Re: Initial Submission Review – Vistas at Beacon Point – Site Plan/Preliminary Plat Comment Responses

Application Number: DA-1616-09
Case Number: 2019-3046-00

SITE PLAN WITH WAIVERS

SHEET NUMBER
U-1
 PROJECT NO. 8174-000

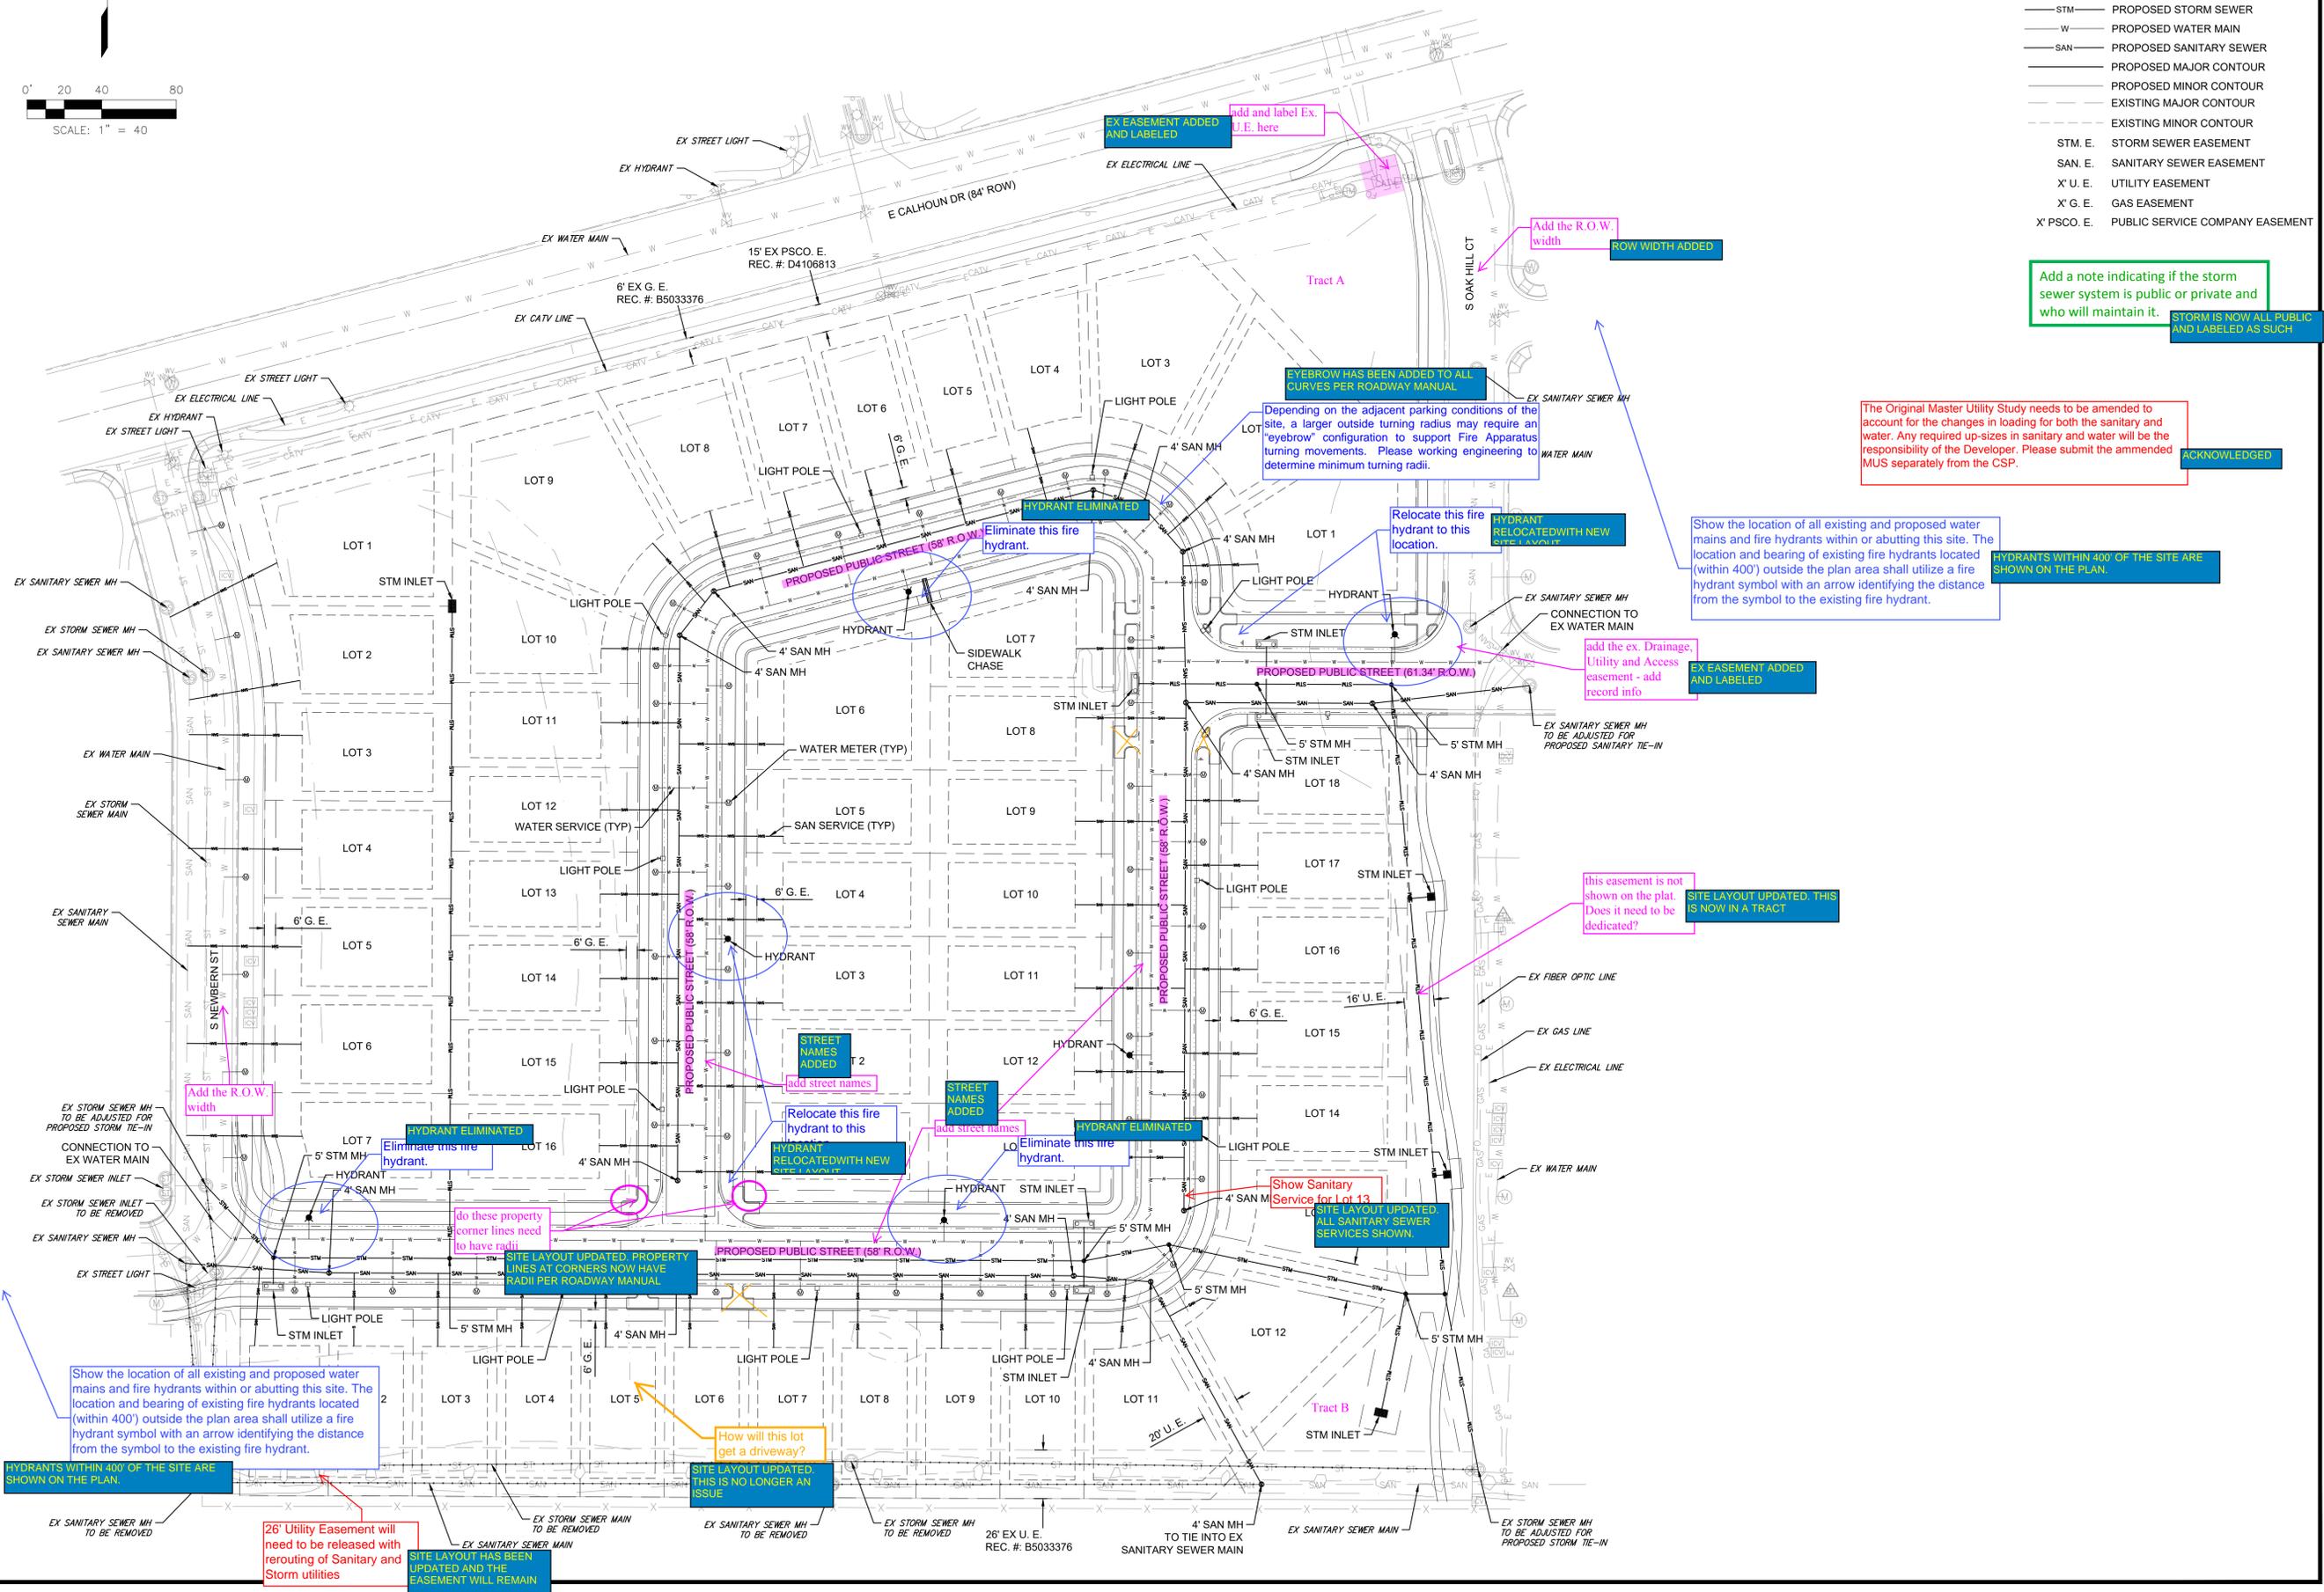
Add a note indicating if the storm sewer system is public or private and who will maintain it. **STORM IS NOW ALL PUBLIC AND LABELED AS SUCH.**

The Original Master Utility Study needs to be amended to account for the changes in loading for both the sanitary and water. Any required up-sizes in sanitary and water will be the responsibility of the Developer. Please submit the amended MUS separately from the CSP. **ACKNOWLEDGED.**

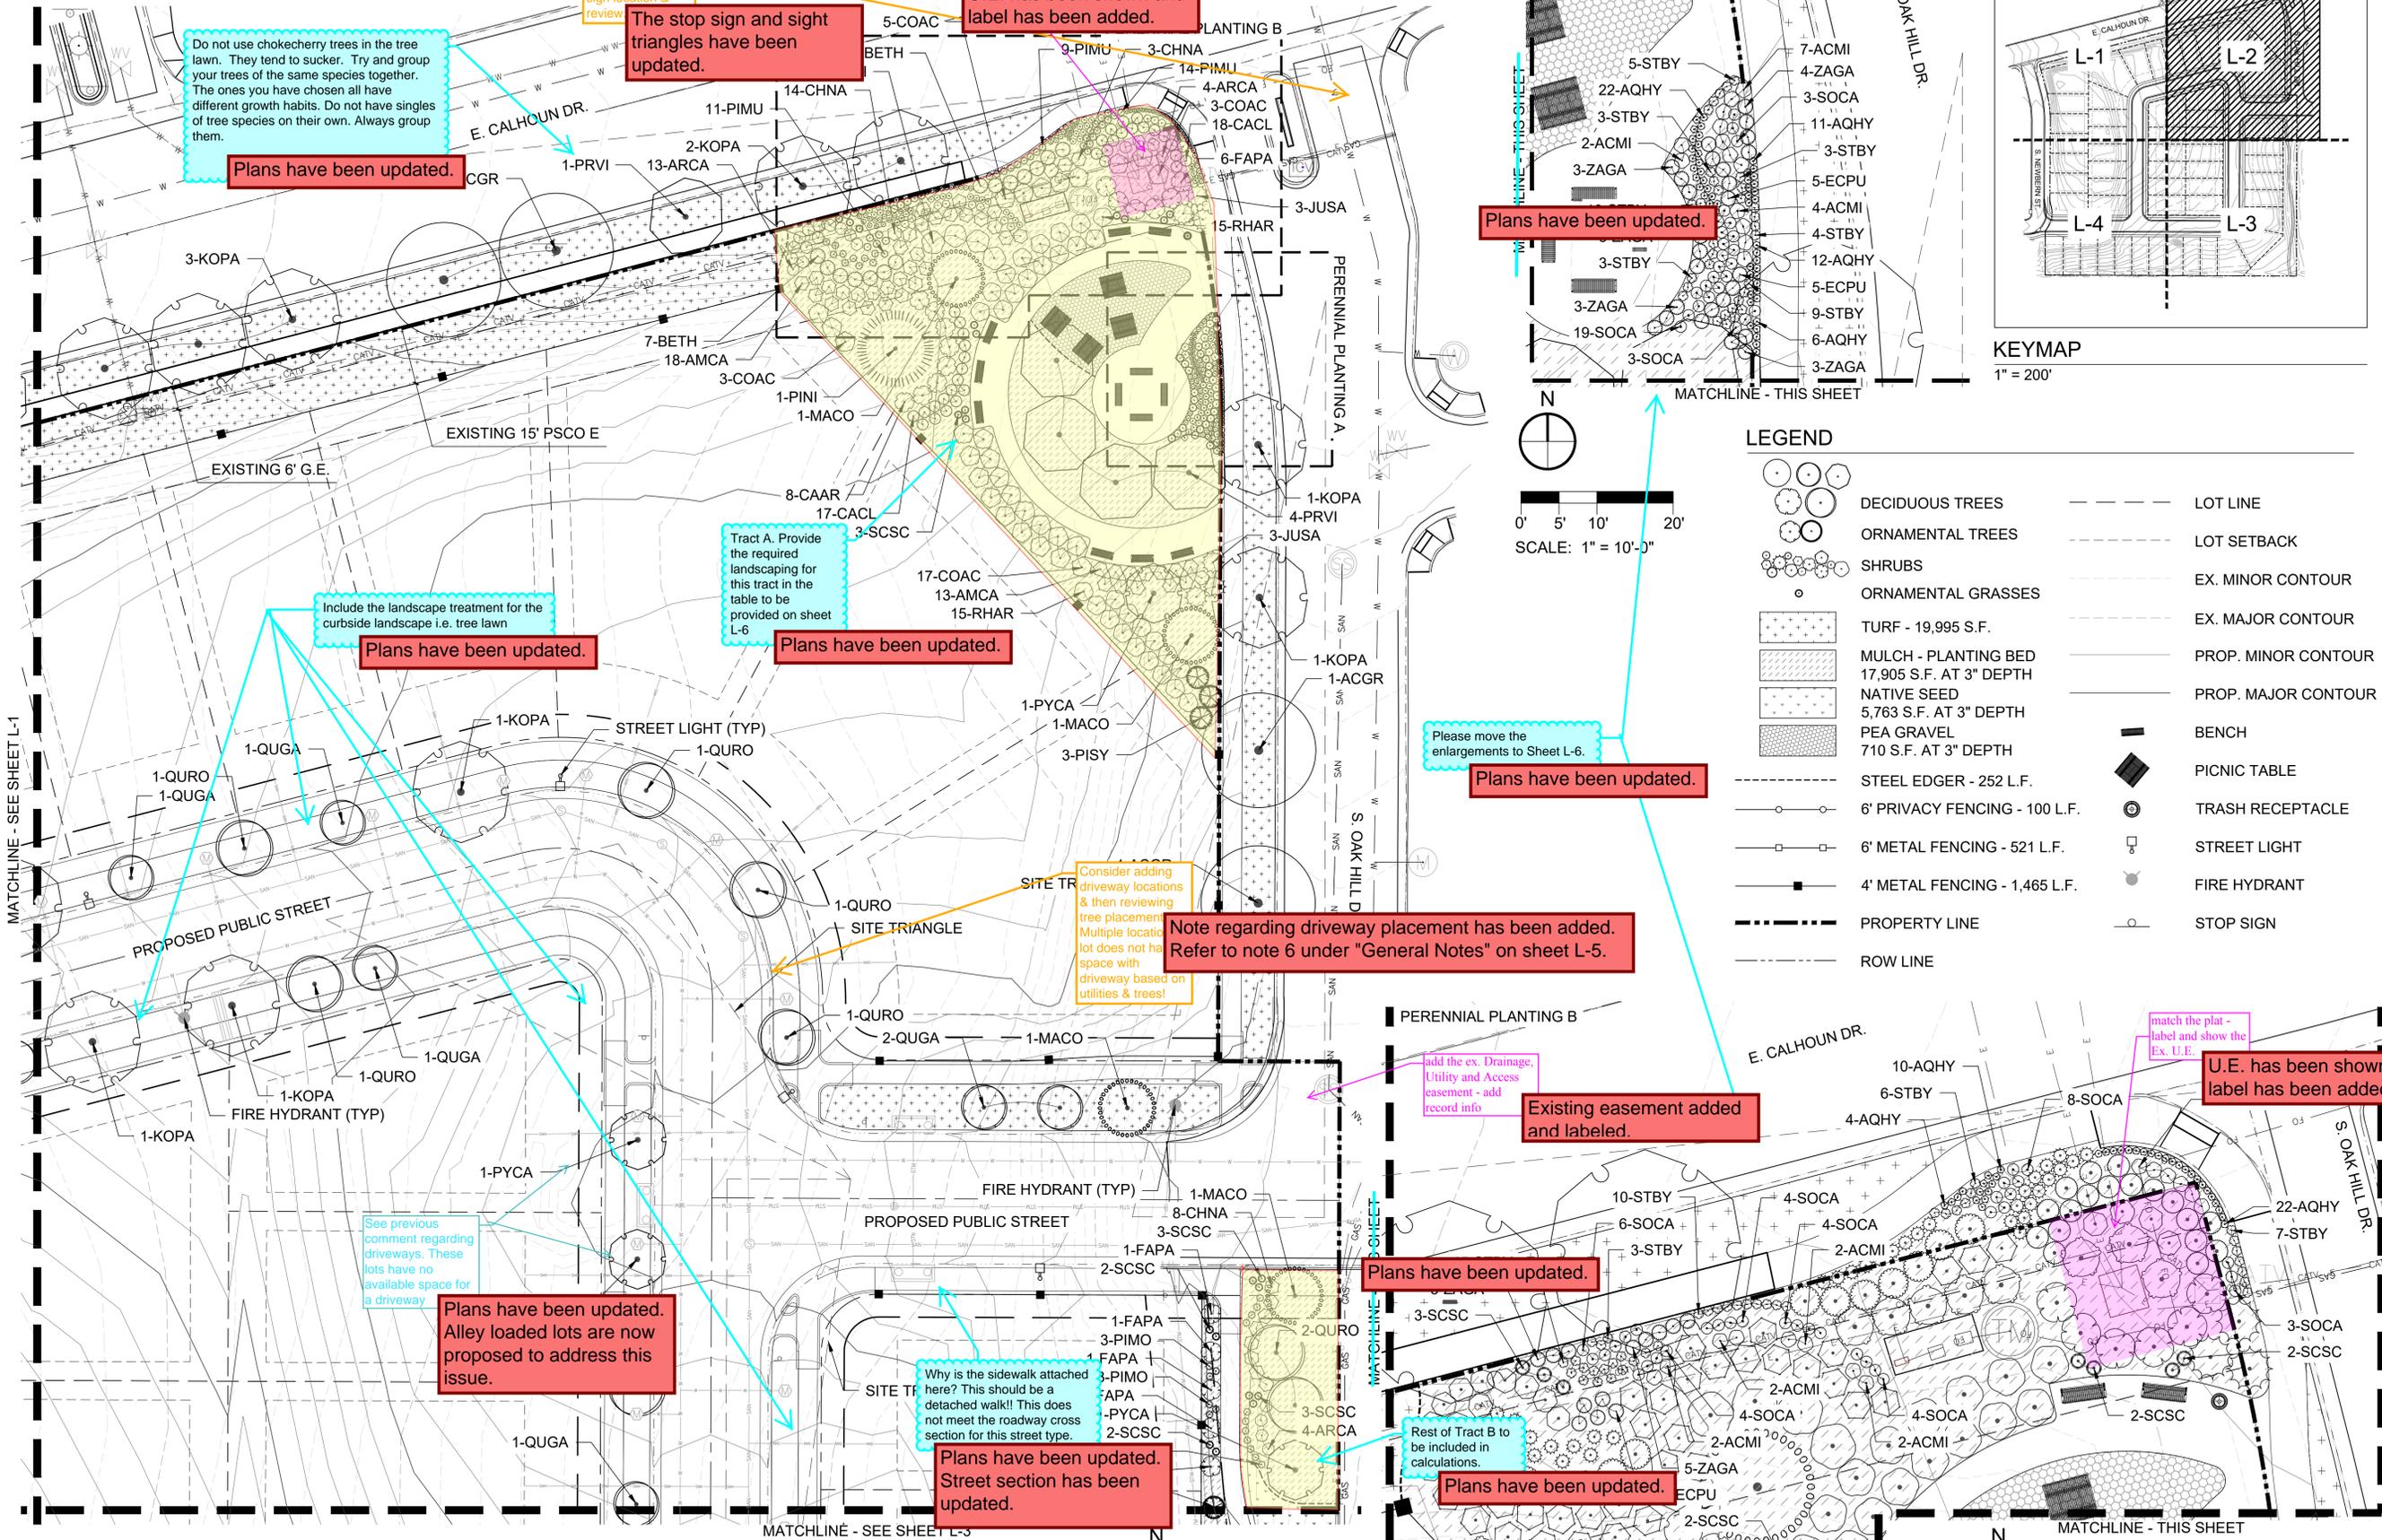
Do not use chokecherry trees in the tree lawn. They tend to sucker. Try and group your trees of the same species together. The ones you have chosen all have different growth habits. Do not have singles of tree species on their own. Always group them.

Tract A. Provide the required landscaping for this tract in the table to be provided on sheet L-6.
 Plans have been updated.

Please move the enlargements to Sheet L-6.
 Plans have been updated.

Note regarding driveway placement has been added. Refer to note 6 under "General Notes" on sheet L-5.

SHEET NUMBER
L-3

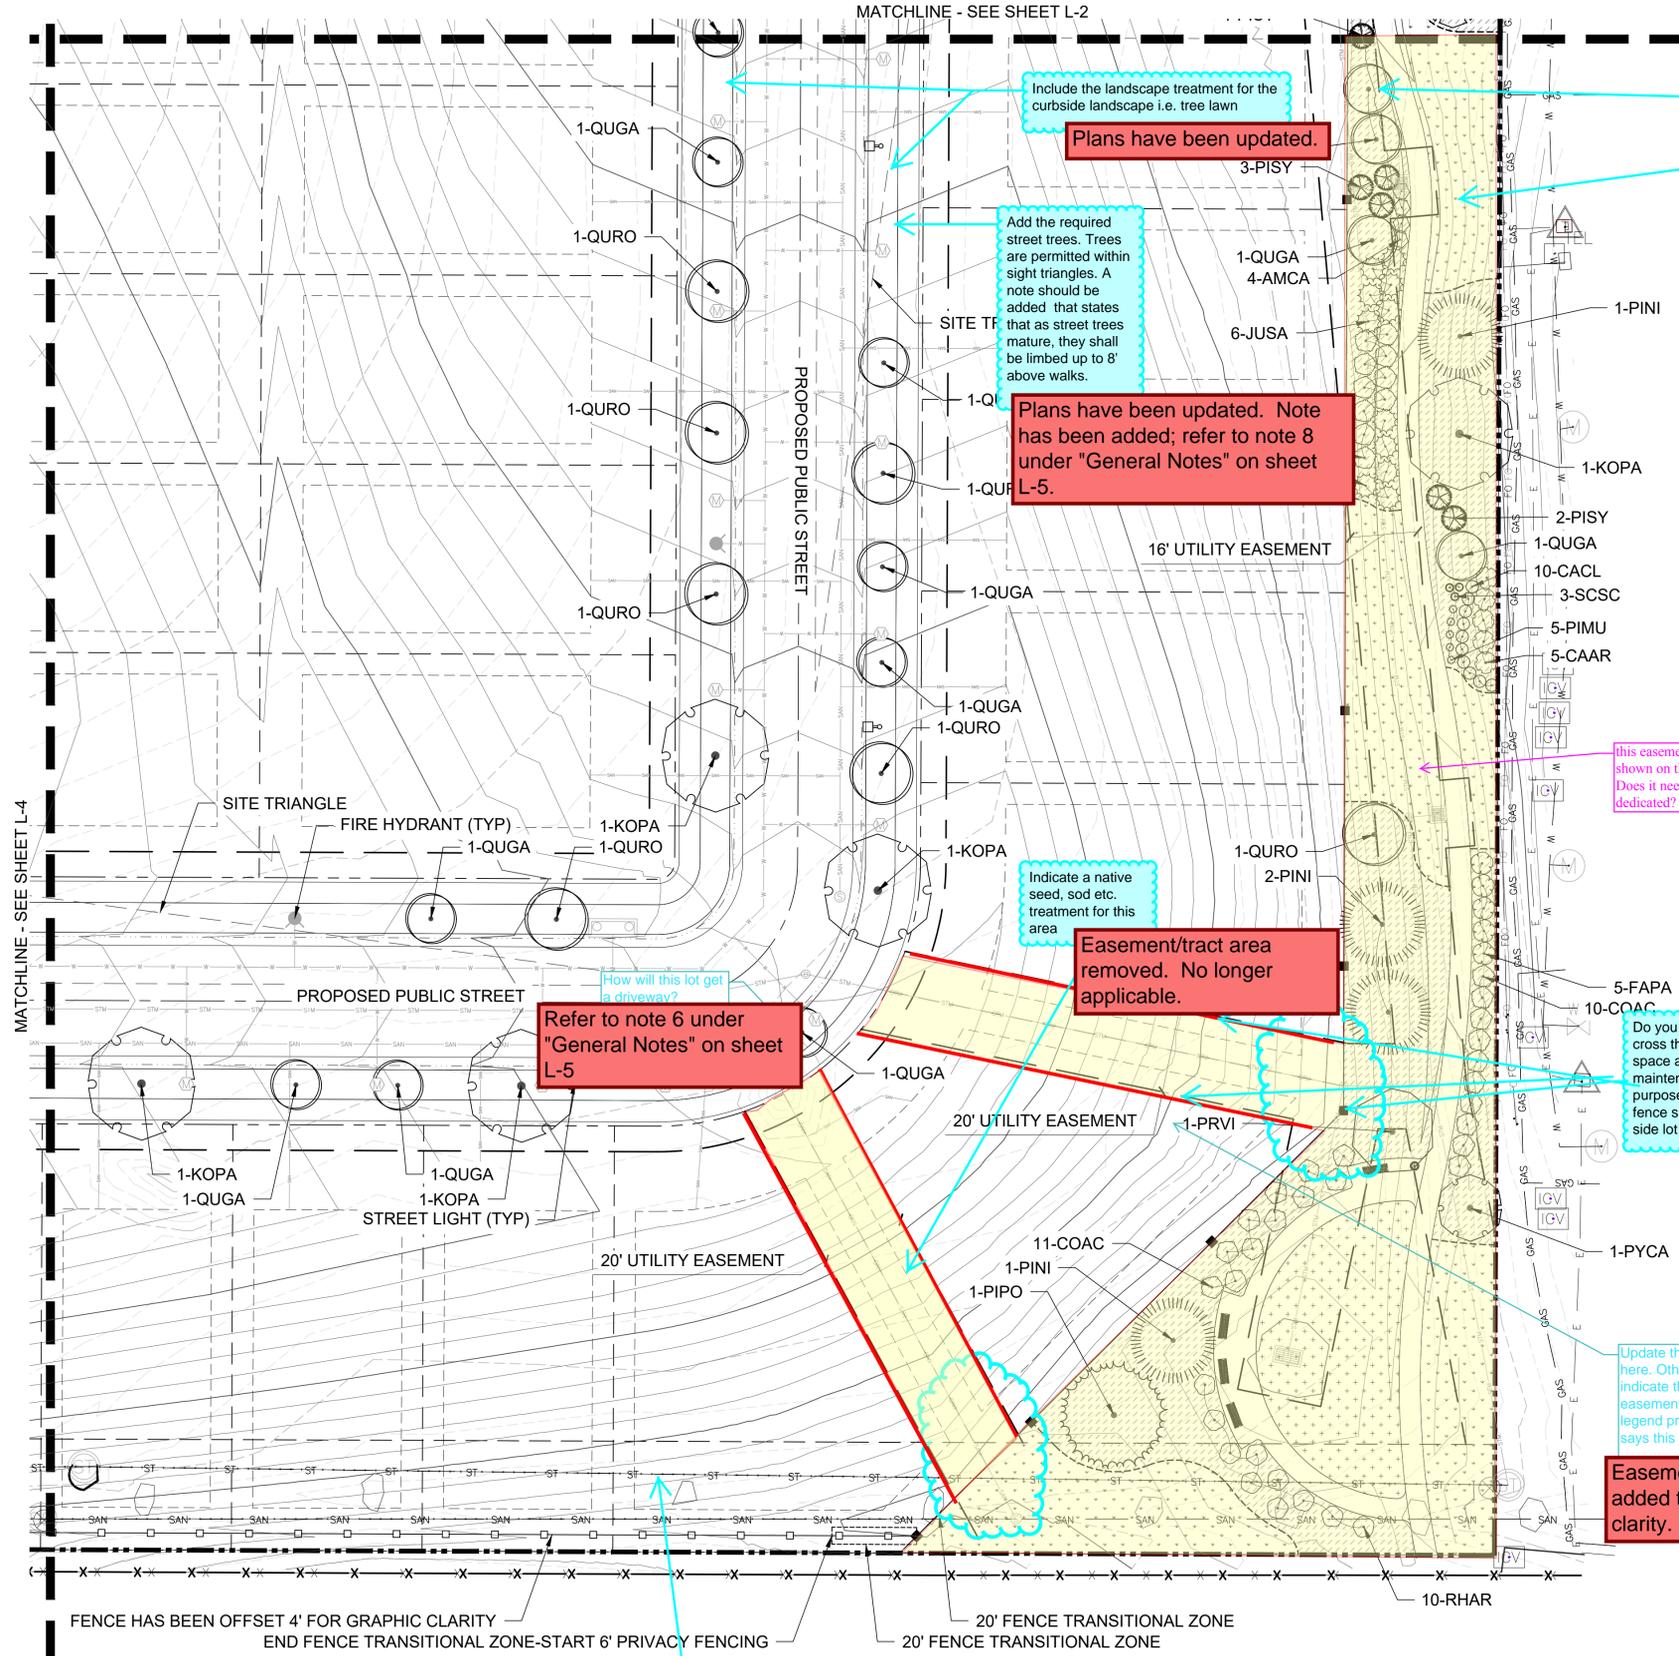
Include the landscape treatment for the curbside landscape i.e. tree lawn
Plans have been updated.

Unfortunately, no trees in the easement
Plans have been updated.

Tract landscaping. Please document this in a chart. See comment on Sheet L-6. According to the Plat, this is Tract B
Plans have been updated.

Based upon Sheet U-1, it appears this storm sewer is being removed. Please turn off any utilities i.e. lines, manholes etc. that are being removed.
Plans have been updated.

Plans have been updated. Note has been added; refer to note 8 under "General Notes" on sheet L-5.
